COMMITTEE DATE: 21/06/2017

APPLICATION No. **16/02916/MJR** APPLICATION DATE: 06/01/2017

LOCATION: LAND TO THE SOUTH OF HAMADRYAD CENTRE,
HAMADRYAD ROAD, BUTETOWN, CARDIFF, CF10 5UY
PROPOSAL: CONSTRUCTION OF NEW 2 STOREY PRIMARY
SCHOOL BUILDING INCLUDING CHANGING ROOMS, WITH
SPRINKLER TANK AND PUMP HOUSE,
PARKING/SERVICING AREA, LANDSCAPING,
RECREATIONAL FACILITIES AND EXTERNAL LIGHTING

DRAWING TITLE
Proposed Ground Floor Plan

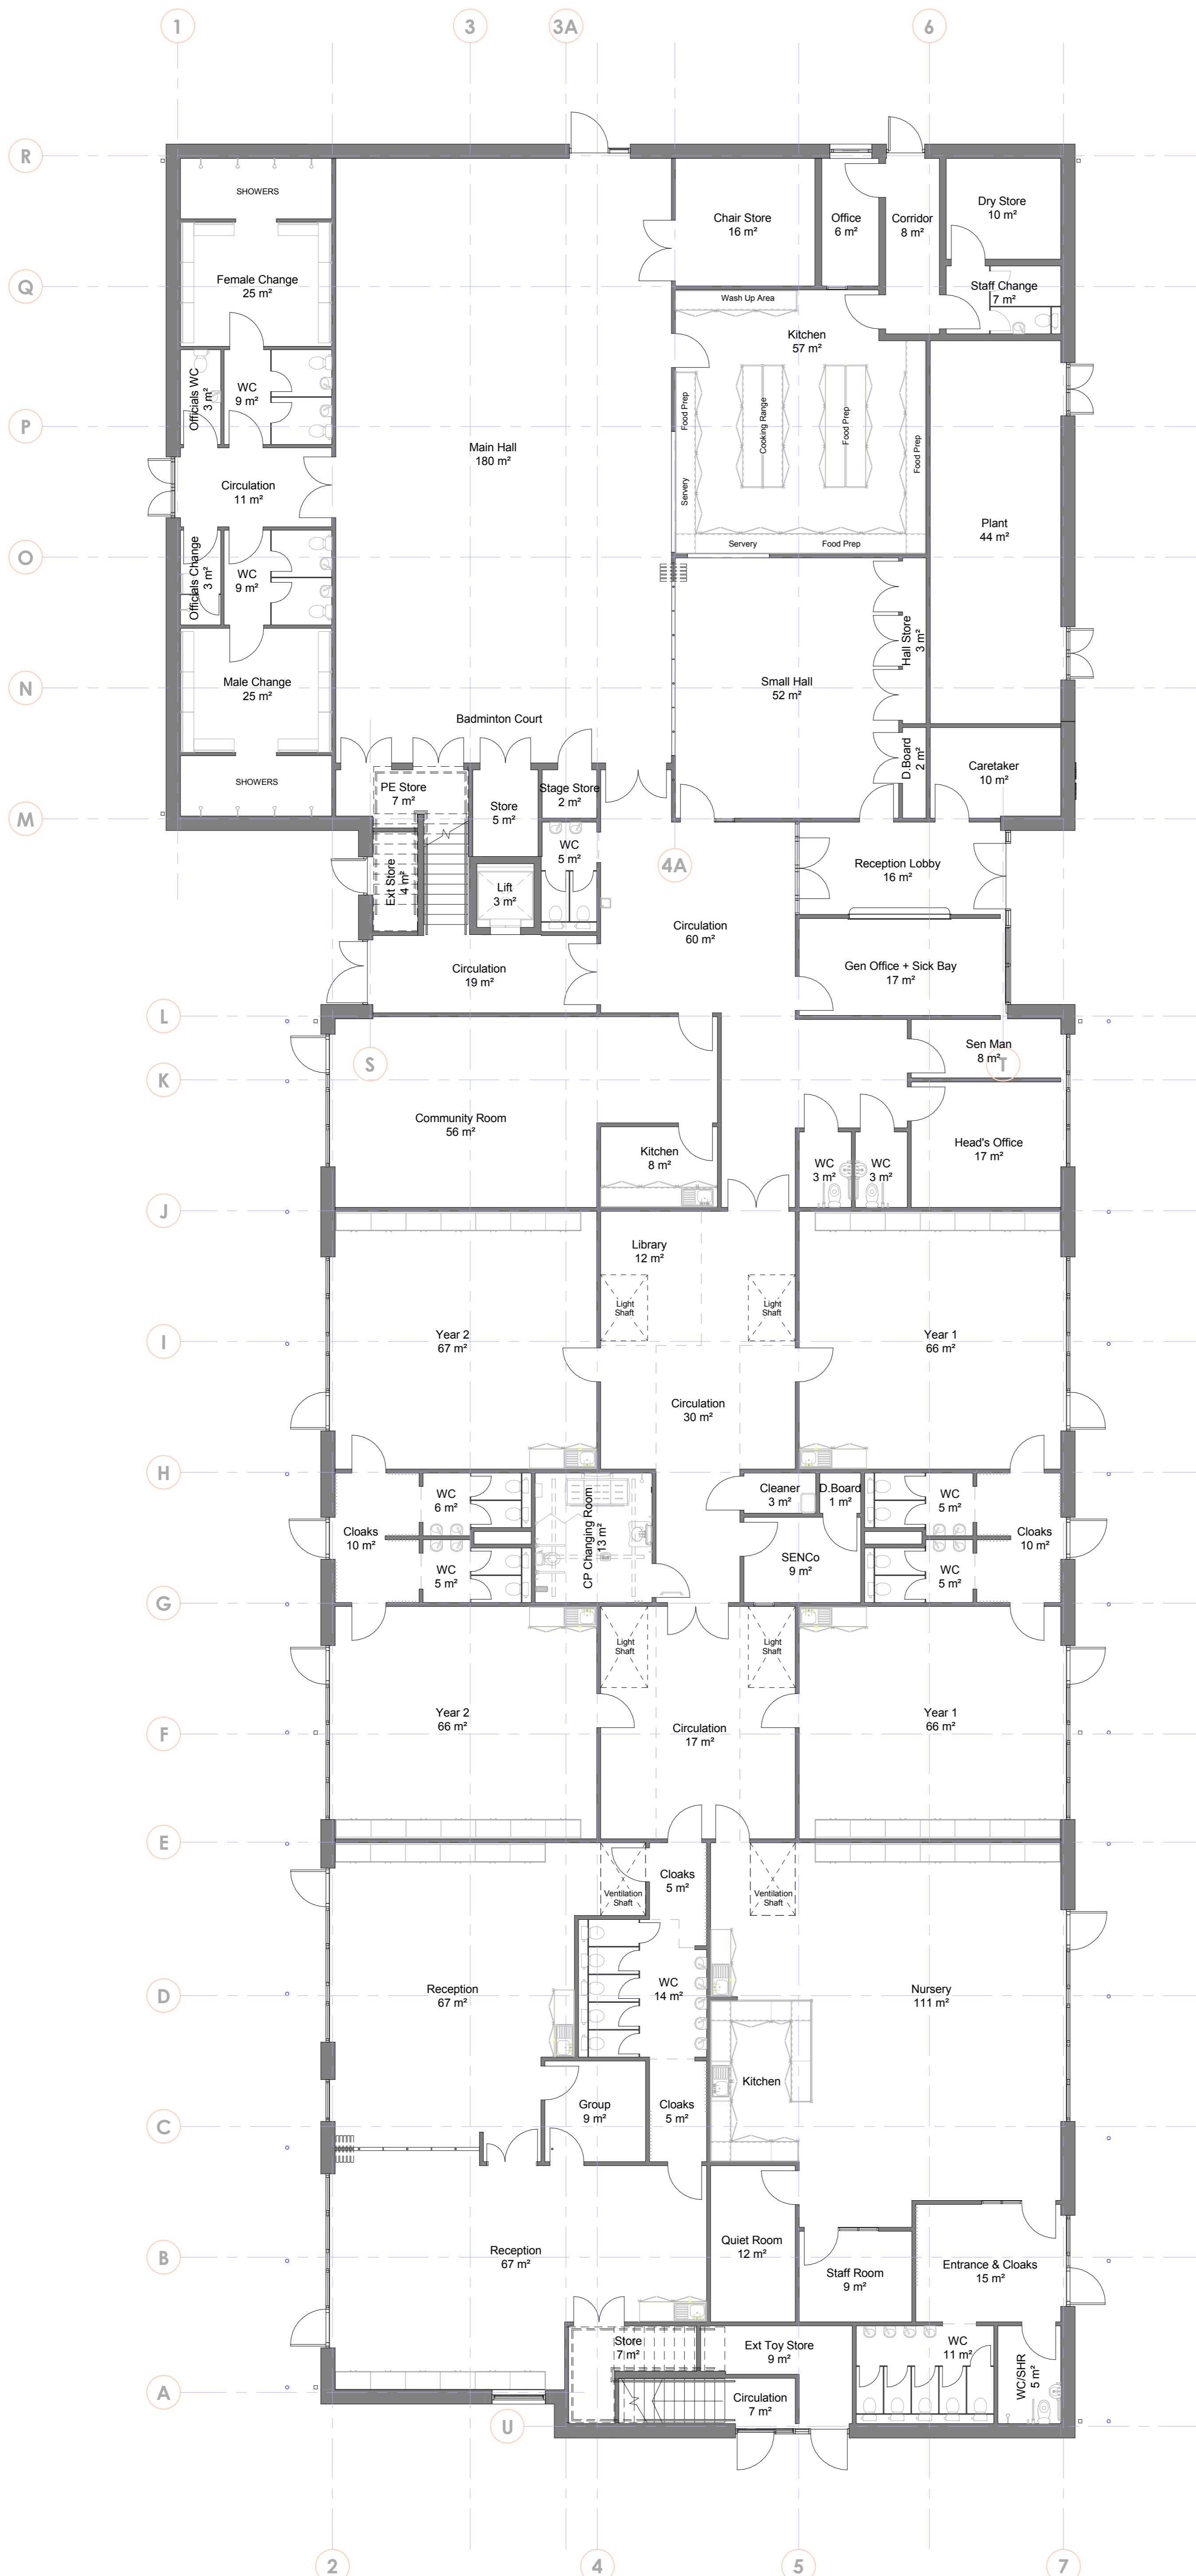
It is proposed that the changing rooms be located in the western wing of the building off the main hall be sized and configured to allow their use by adults and hence enhance use of the outside football pitches on Hamadryad Park. In this context, the changing rooms fall below local senior league standards as indicated below in the following respects:

- Adequate toilet facilities exclusively for the use of players, separate toilet facilities should be provided for each team. There shall be a minimum of

1 W/C and 1 urinal, with hot and cold running water for the use of the teams within the vicinity of each dressing room complex. Please note existing plan does not include a urinal.

- Separate dressing rooms must be provided for match officials, the minimum size of which shall be 4 square metres excluding shower and toilet areas. Please note existing plan shows 3 square metres
- The match official's dressing room should have at least 1 working showerhead (ideally en-suite). Please note the existing plan does not include a shower for official.

- I note that rear double doors could allow access to the main hall and other areas of the school. I would suggest that these cannot be opened from inside the changing room and should have a secure (heavy duty & lockable) door.

- 8.12 The issues identified by the Parks Officer relate primarily to management and internal accommodation matters that should be addressed between the Education and Parks Departments. A modest rearrangement within the changing room area could address the Parks Officer's concerns and the submitted plan shows a showerhead for the official. It should be noted that one of the changing rooms is identified for female use clearly indicating that the changing rooms are not solely for all male use. The means of enclosure is covered by proposed condition 21.
